Selected Non-Proprietary  
Correspondence from Boeing to Captain S. Kelada and Engr. Hamdy of EgyptAir

Split Elevator Failure Scenarios  
Effect of High Rate Column Inputs  
Dynamic Analysis  
Autopilot Disconnects on DFDR  
Action Items

9 June 2000 thru 15 December 2000

Subject: Split Elevator Failure Scenarios - Egyptair 767-300ER SU-GAP,  
Accident Off Nantucket, Massachusetts – 31 October, 1999

Figure 2

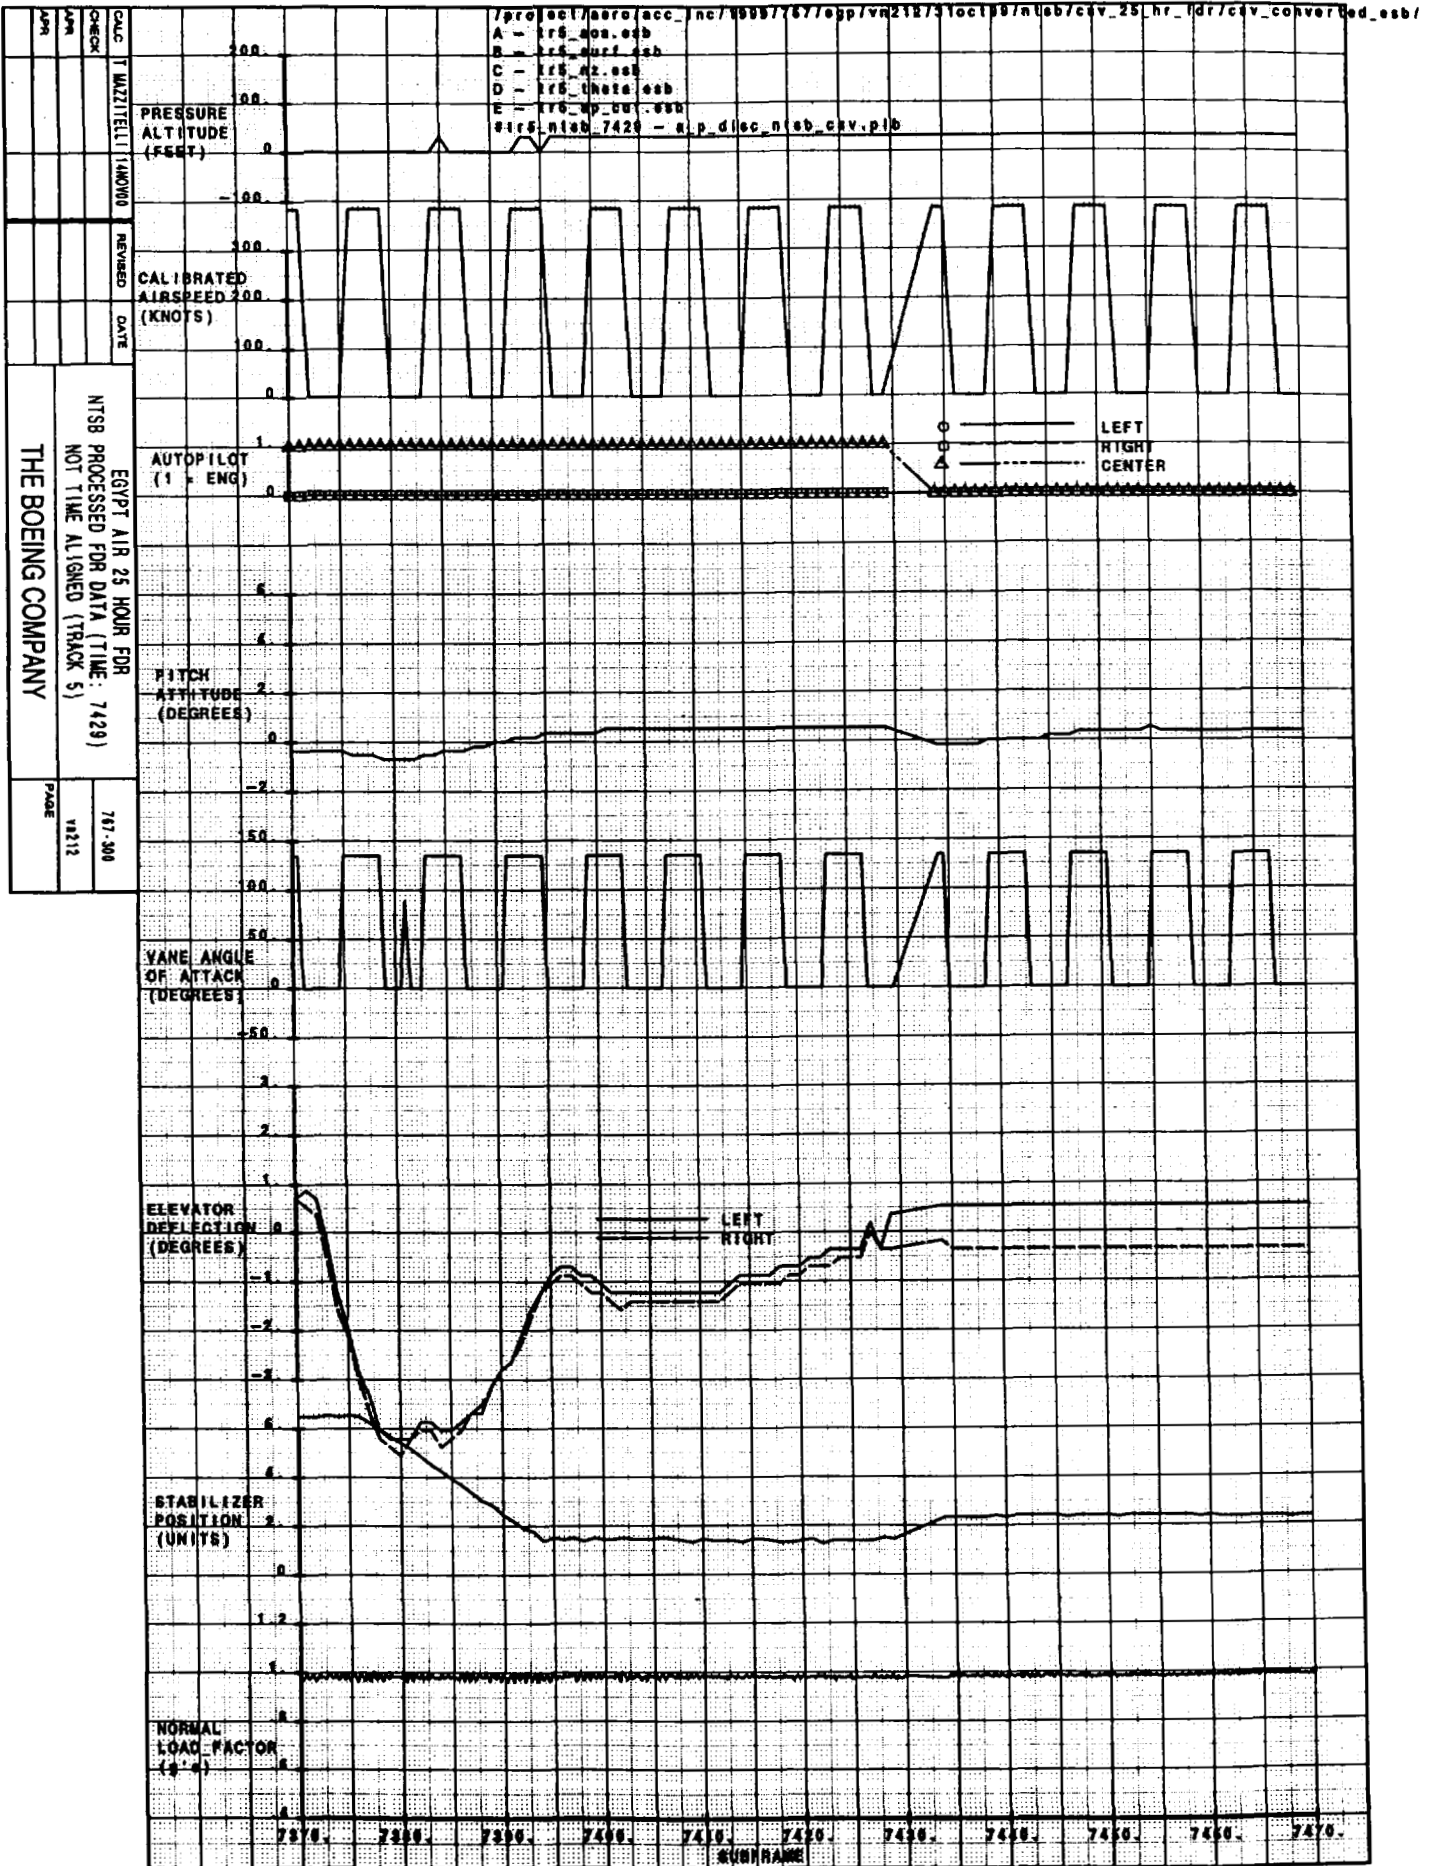
As requested by the Egyptian Delegation (ED) in reference (a), the ED asked Boeing to review the small elevator surface deflection downward and asymmetric elevator surface motion which occurred immediately after the autopilot disconnects recorded on the digital flight data recorder (DFDR) of the subject airplane. Also in reference (b), you requested three additional items: 1) data plots for all autopilot disconnect events, 2) FDR track and sub-frame number for each autopilot disconnect event, and 3) resolve a concern regarding missing data on figure 2.

Figure 2 presents the DFDR data from an on-ground autopilot disconnect. This autopilot disconnect event is different from all of the other events in that the DFDR was not powered at the time that the autopilot was disconnected. The lack of symbols on the autopilot engage status discrettes of figure 2 during sub-frames 7430, 7431, 7432, and 7433 indicates that the DFDR did not record any data during these sub-frames. An examination of the data shows that at sub-frame 7429, the center autopilot was engaged and the GMT was 22:32:24. At sub-frame 7434, all autopilots are disengaged and the GMT was 1:12:25. A period of 2:32:02 or 2.53 hours elapsed between the time that the DFDR recorded sub-frames 7429 and 7434. While not shown on figure 2, the reason for this time lapse is evident from the N1 and EPR parameters: the engines were turned off during this period which in turn made the DFDR stop recording.

The NTSB method of processing the DFDR data from this event resulted in the sub-frame numbers getting incremented four times (7430, 7431, 7432, and 7433) when no data was actually recorded in order to complete the data frames that existed before and after the DFDR power cycling. Figure 2 in the original version of this document contained Boeing processed FDR data. The data file that Boeing used to compute sub-frame information was missing these incomplete data frames and as a result the original version (reference (a)) of figure 2 appeared to have continuous data. Now that this letter uses only the NTSB processed DFDR data and its associated definition of a sub-frame, it is clear that figure 2 is missing data for four sub-frames.

Since the DFDR was not recording data when the autopilot was disconnected in figure 2, there is no information regarding any elevator surface transients that may have been produced as a result of the disconnect event itself. Figure 2 is useful for autopilot disconnect analysis only in that we know the

During the time period that the autopilot was engaged in figure 2 (all sub-frames less than 7429), the tracking of the two elevators is excellent with a tracking difference of about 0 to 0.17 degrees (0 to 1 LSB).

During the time period after the engines were re-started in figure 2 (sub-frames greater than 7434), the autopilots were disengaged. The elevator tracking difference is 0.87 degrees (5 LSBs) with the left elevator at 0.52 degrees of nose up elevator and the right elevator at 0.35 degrees of nose down elevator. The fact that the two elevator positions do not change at all during this 35 second period in figure 2 is convincing evidence that there are no pilot forces present during this period and hence that this is a stable configuration for the no-load elevator control system.

The no-load elevator control system equilibrium of figure 2 is very similar to that of figure 1. The elevator tracking differences have similar magnitudes and the direction is the same with the right elevator being more nose down than the left elevator. The fact that the average elevator deflection at neutral is a little more nose up in figure 1 than figure 2 is probably due to the friction effects since the elevators were returned to center from different directions.
